ADDENDUM TO RFP DOCUMENTS

SOLANO COMMUNITY COLLEGE	ADDENDUM #02
	Project: Solano Community College District Vacaville Center HVAC Upgrade Project Project #18-010
	Date: February 28, 2018

Addendum # 02 – The following clarifications are provided based on questions received and must be added/considered when completing your submittal: Acknowledgement of receipt of this **ADDENDUM** is required in the proposal’s cover letter of introduction. Please clearly note the addendum date and number.

PROJECT NO.	419-202
DRAWN BY	CHKD BY
DATE	02/20/08
SCALE	
TITLE	EXTERIOR DETAILS - ROOF
NUMBER	A8.51

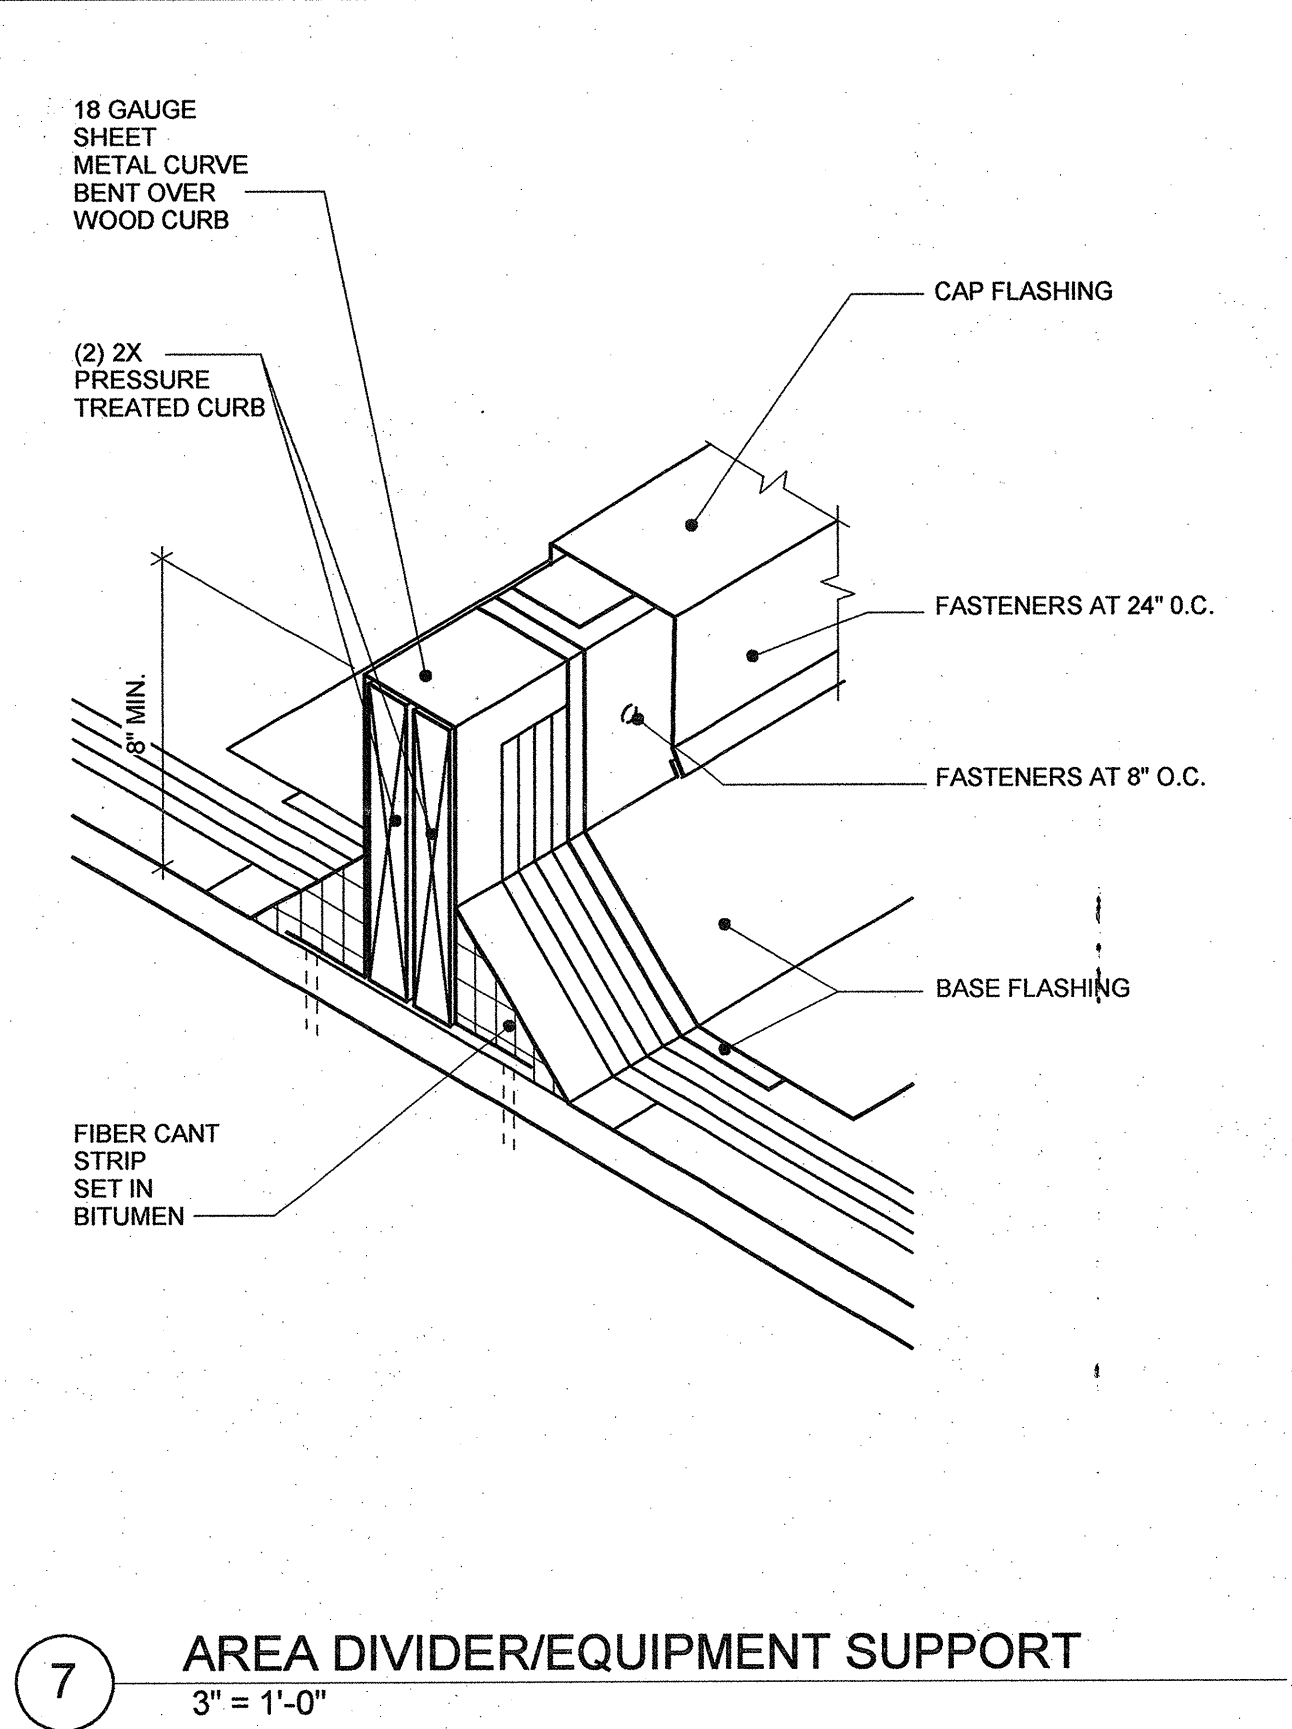
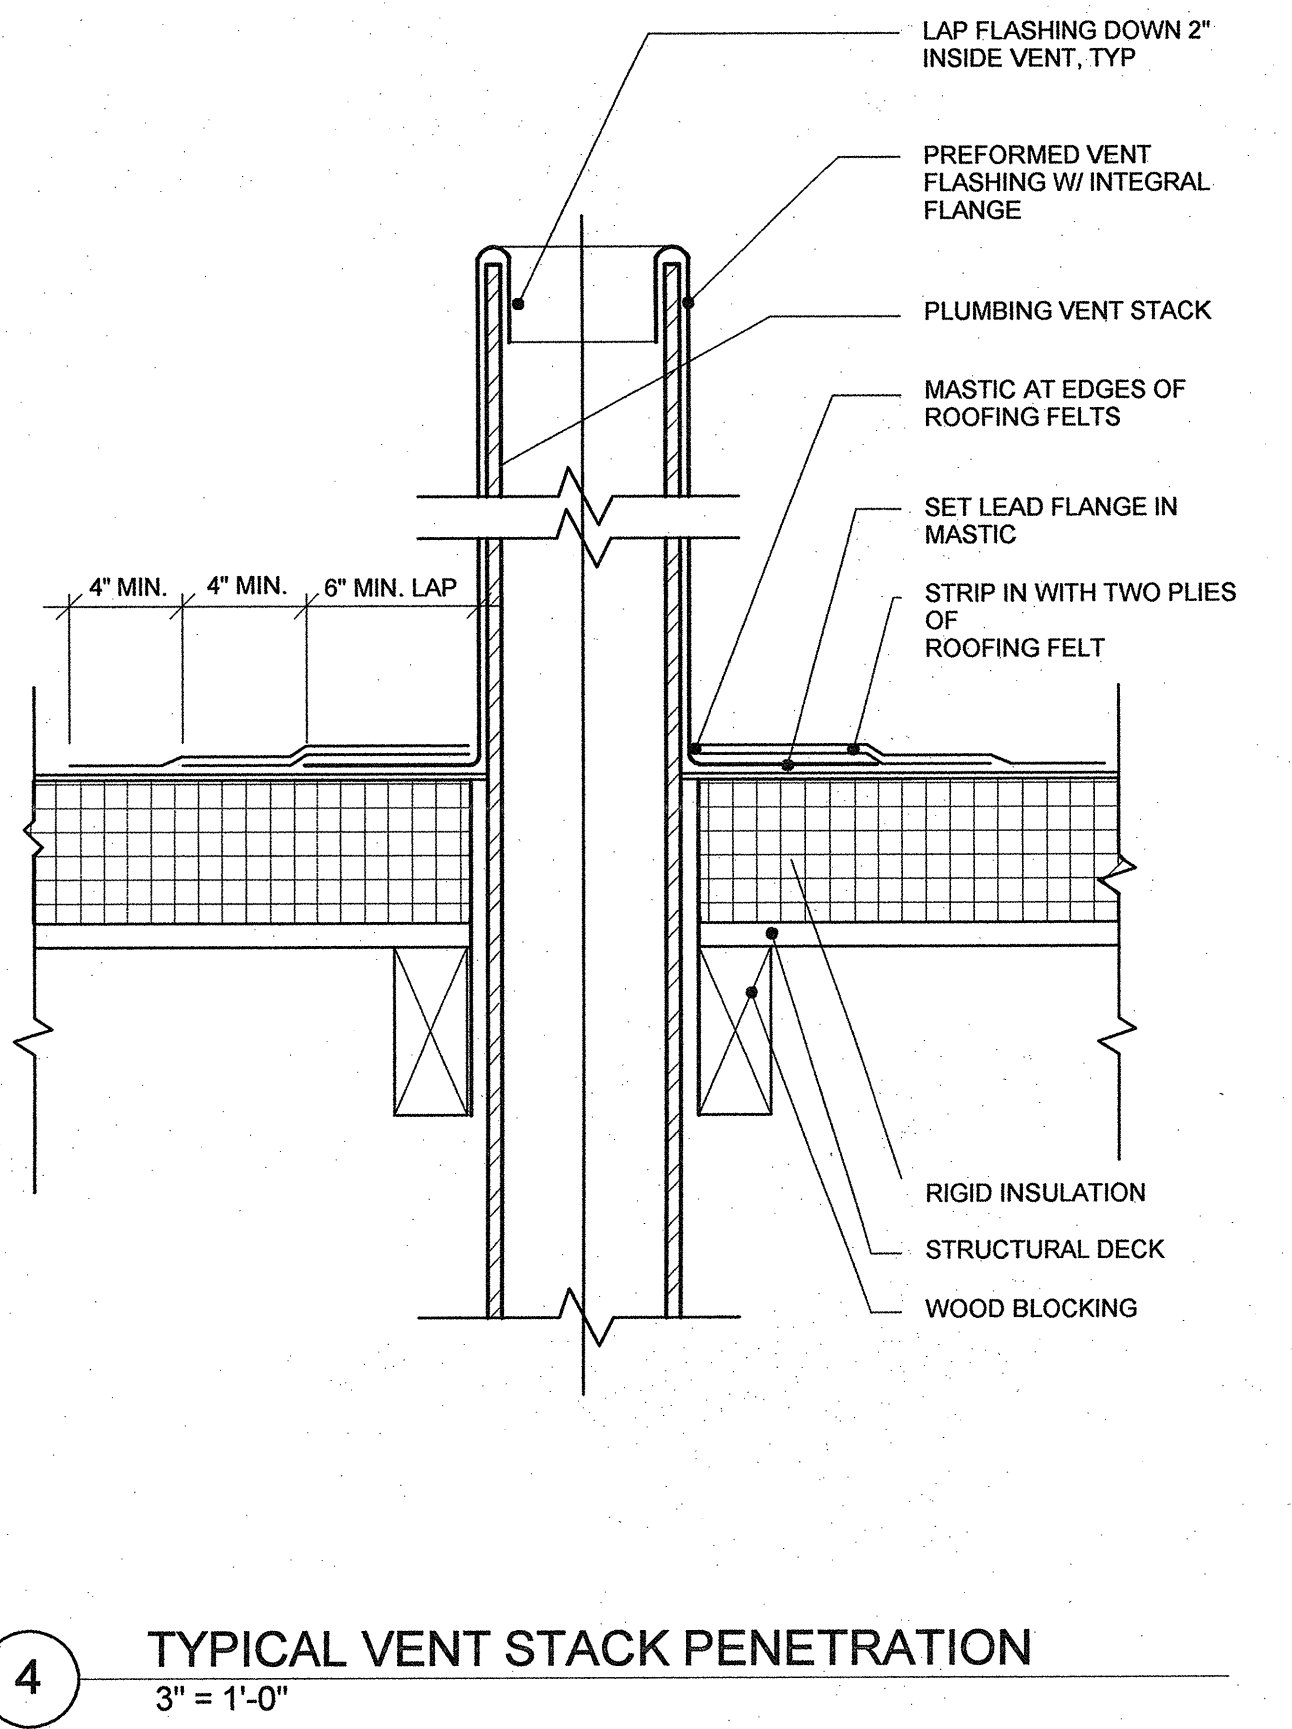
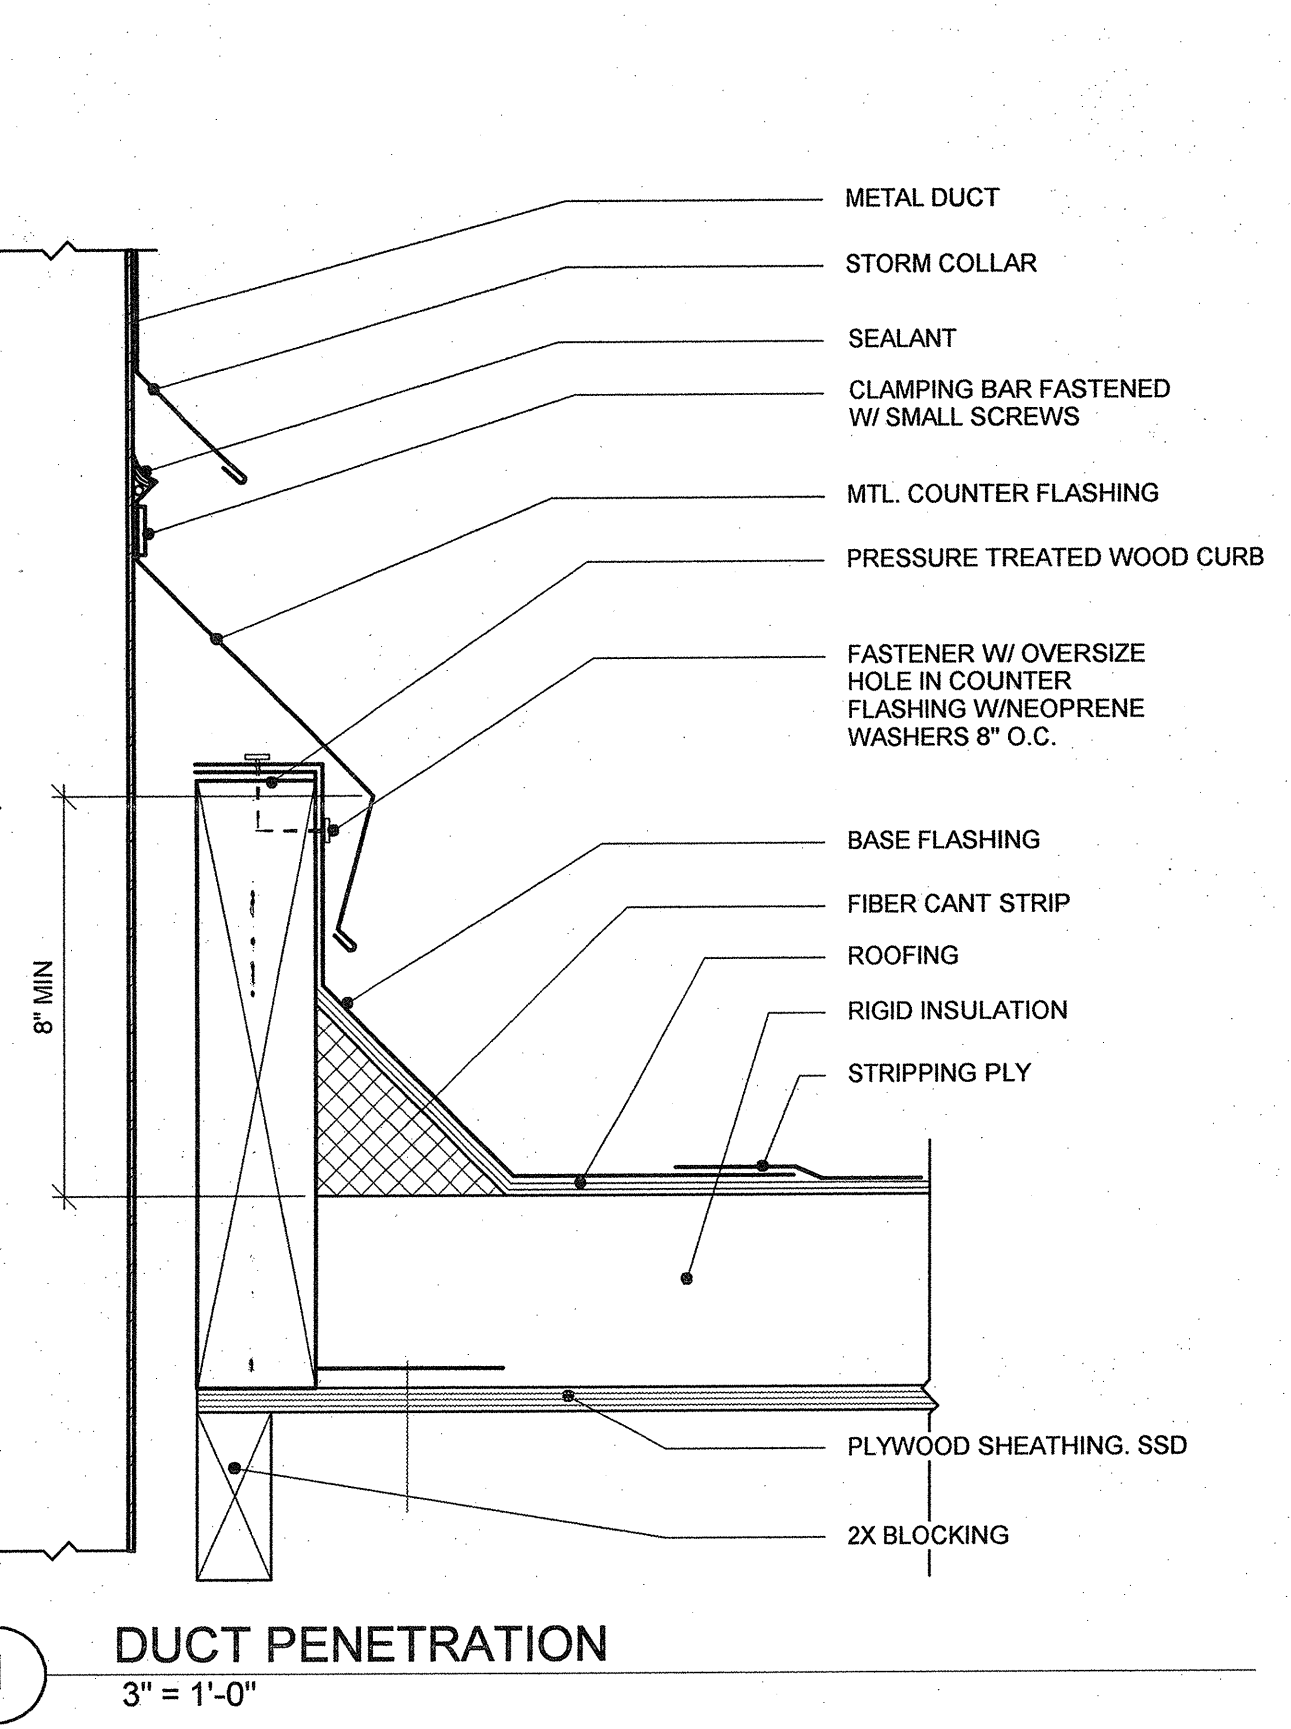
QUESTION –During the job walk it was determined that the existing roof system is fully tapered by rigid insulation ½” in 12” slope with a minimum of 6” at drains but not shown on the drawings. Please confirm and provide new details identifying existing insulation.

ANSWER – Please see the attached As-built drawings: A8.51, A8.52 & A8.53 for all the info of the existing roof condition (see attached).
